SECTION 92 RESPONSE – GREY LYNN TUNNEL

Further to your recent instructions, we are pleased to provide this response to the Section 92 request for further information issued by Auckland Council dated 21 March 2019. It is noted that the Council response is detailed first, with the Commute response below.

Figure 1: Vehicle Access

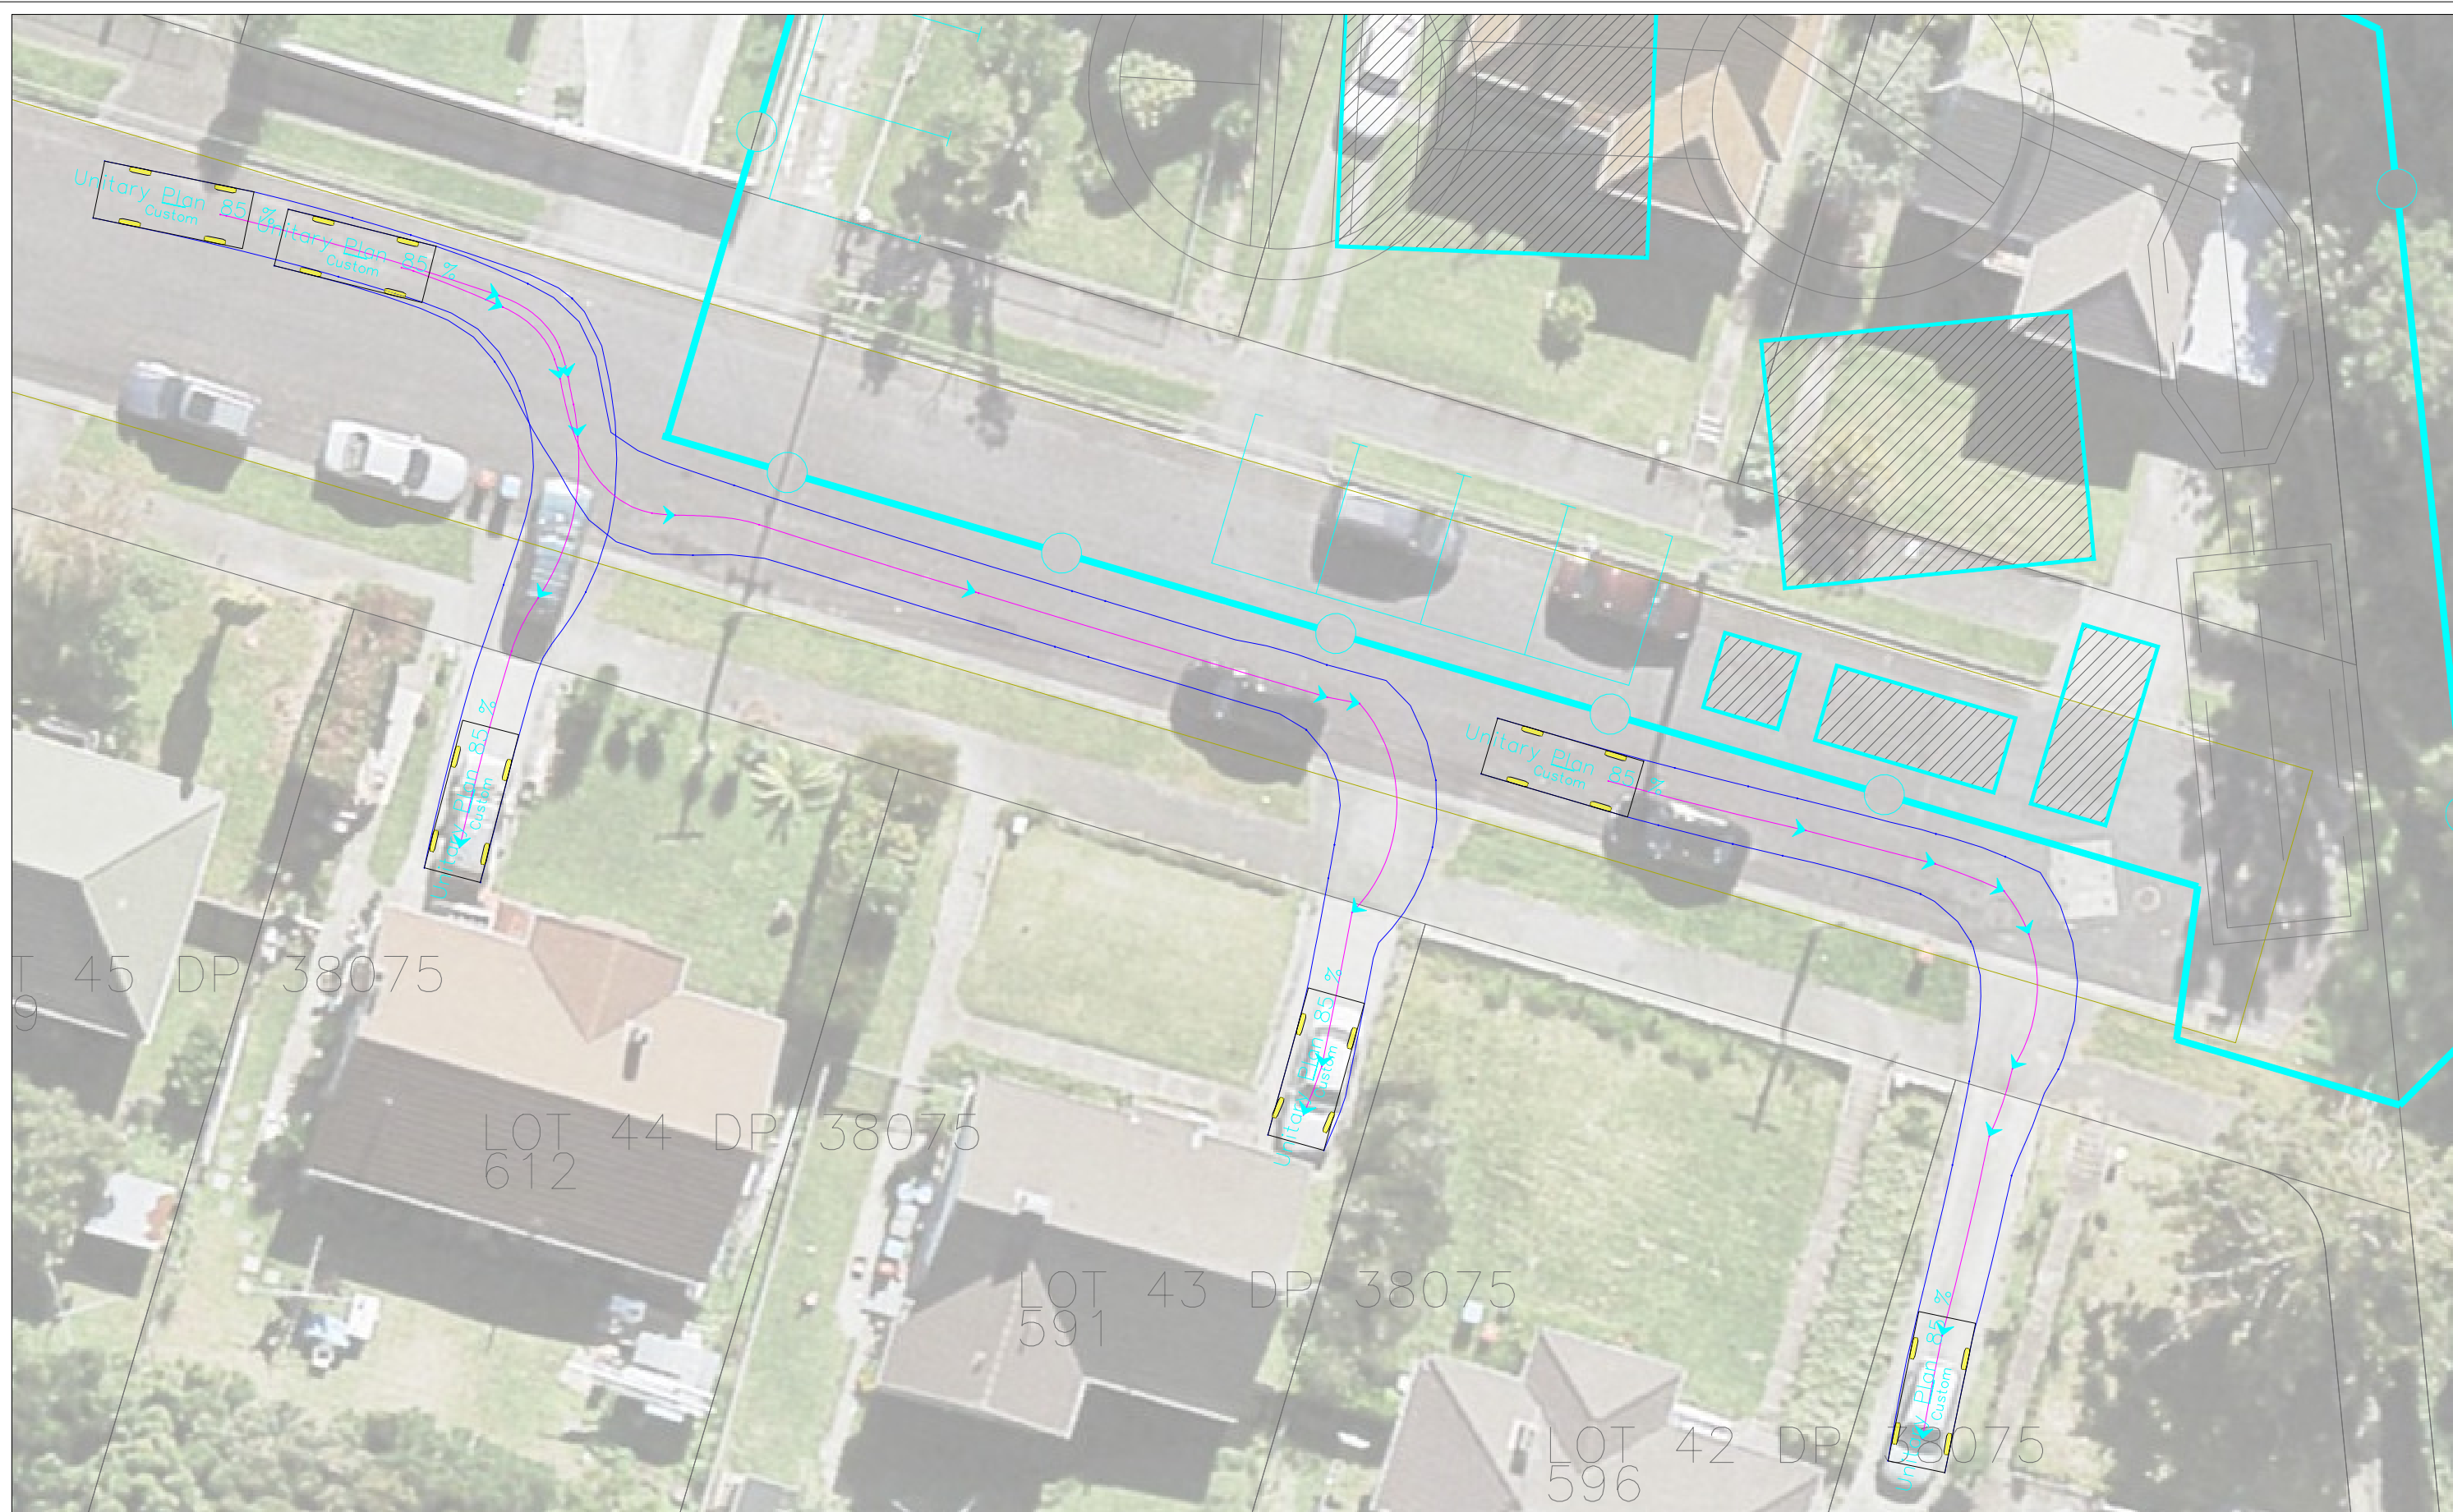
- 24. Vehicle access: The proposal states that the access design is to be confirmed at detailed design stage. However, its future position might have implications for the neighbouring property at 42 Tawariki Street such as the distance in between vehicle crossings and safety concerns. Please provide confirmation that the proposed vehicle crossing will comply with the AUP (OP) relevant standards, including how the crossing will meet relevant construction standards.

As detailed in Figure 1 below, the site vehicle access and the property access to 42 Tawariki Drive are perpendicular, and therefore aren't a typical case as assessed

against the AUP rules. It is noted that vehicles can safely and efficiently manoeuvre into and out of both accesses with the proposed arrangement. It is recommended that vehicles are restricted from parking in either access driveway, to ensure access to both sites is maintained at all times.

Revision notes:			Drawn by:		Date:				Figure:	
Rev:	Date:	Notes:	JB		17 April 2019				A1	
			Client:		Scale @ A3:					
					1:200					
			Drawing Title:		Revision:					
			Car Entry		A					
			Grey Lynn Tunnel

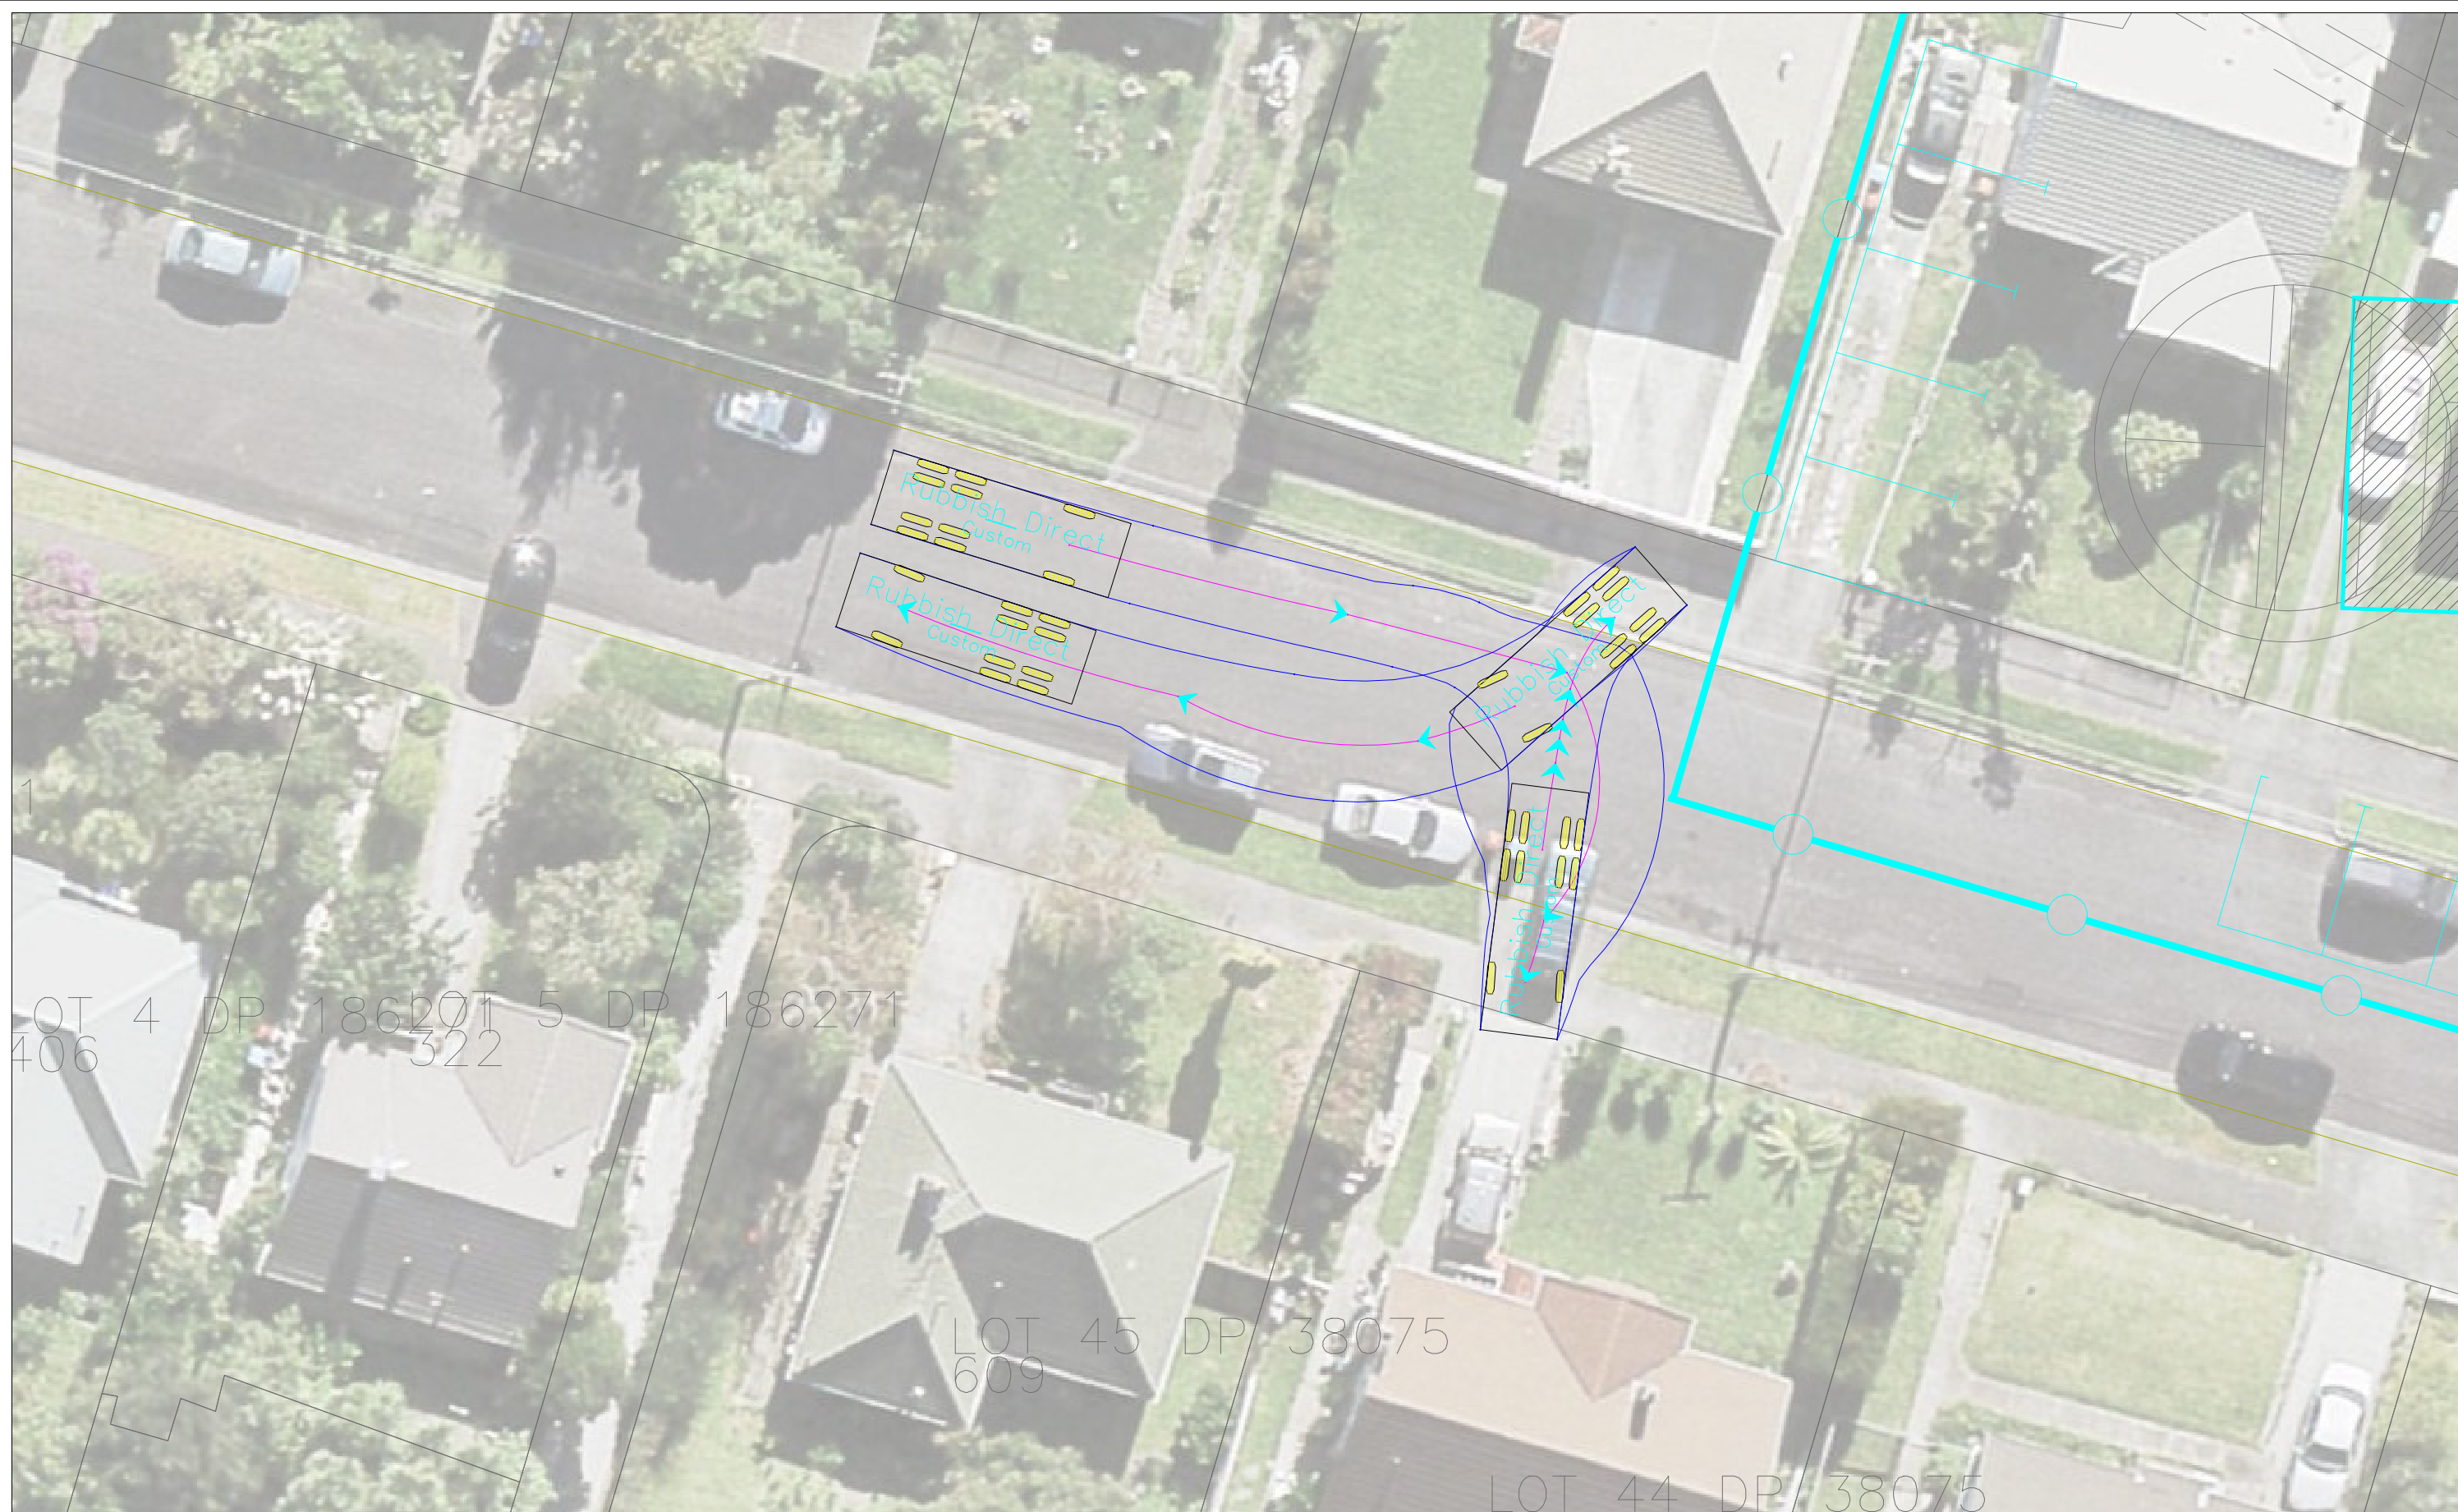
1. Please provide tracking assessments to demonstrate that vehicular access and egress to the properties on the opposite side of Tawariki Street at 35 to 41 Tawariki Street (particularly 41 Tawariki Street) will be maintained during construction. (Note: see also RC21).

Vehicle tracking has been undertaken for the subject properties detailed above and is detailed in Attachments A1 and A2. As seen in the attachments, access is maintained for all properties, with vehicles able to safely and efficiently access and egress the properties.
